IC Corporation

NON-COMPLIANCE RECALL 06505

September, 2006

Bottom Davenport
Panel to Floor RE
Joint

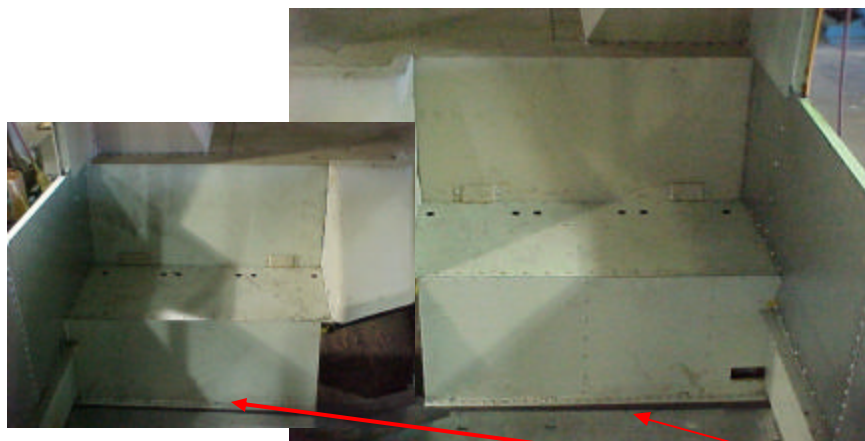
The joint where the davenport meets the bus floor may not meet the required minimum joint strength. This has been determined to be noncompliant with FMVSS 221 (571.221 S5.1, 5.1.1, S6.2).

This repair involves securing three flat retaining bars along the front of the davenport joint. The retaining bars are secured with 1 1/2" screws spaced at 1 1/8" installed through the floor covering, plywood (if applicable), the davenport closeout's lower flange, and into the floor's substructure. The davenport closeout's lower flange is typically not visible beneath the floor mat and plywood (if applicable). There is only one part number for one length of retaining bar. The two shorter retaining bars are made by cutting the longer bar to the appropriate length.
